Upper Hutt City Council Private Bag 907 UPPER HUTT 5140 Upper Hutt Town and Country Assn c/-Bob McLellan
7 Paton St
Mangaroa
Upper Hutt
info@uhtca.org.nz
4-5267775

28-09-2017

Plan Change 42

MANGAROA RIVER: UHCC PC4z REFINE (Flood Depth > 0.1m)

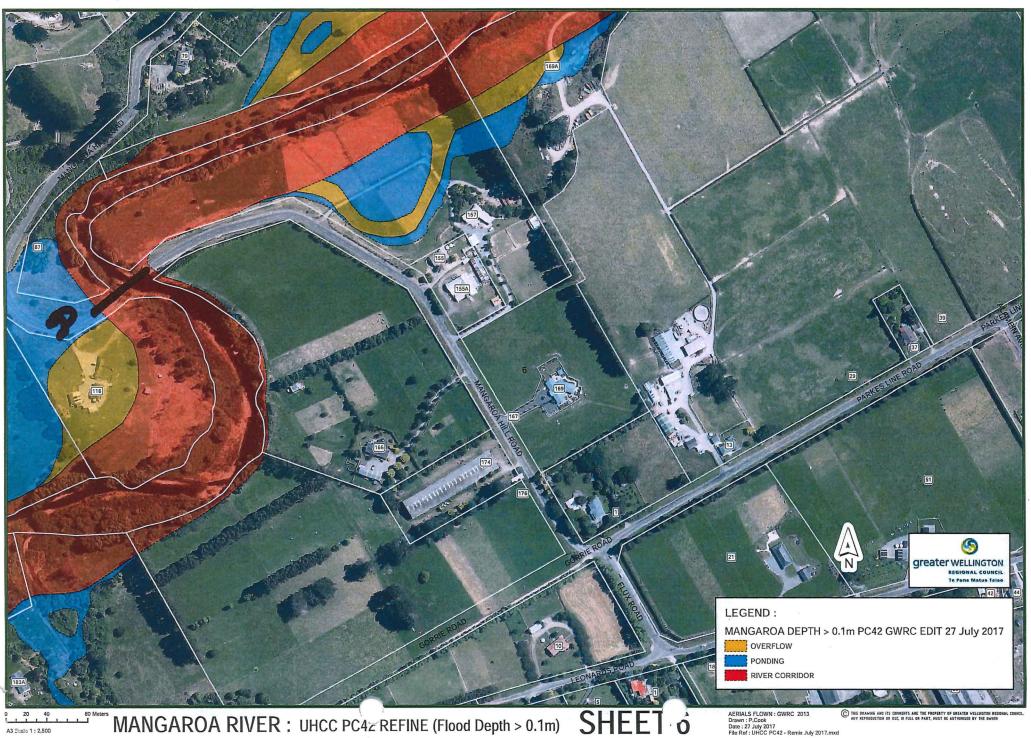
By way of an exercise we measured the cross section of two positions on the Mangaroa river which have basically the same amount of water and the same water speed. The position B has a cross section 2 to 3 times greater than A. So how does the adjacent higher ground become river channel. It has not gone under in living memory. Is it by erosion? In that case it should be treated that way.

Anomalies like this abound along the river and reviewing each one is too time consuming. What is needed is maps that are self explanatory and have the information needed to answer any questions.
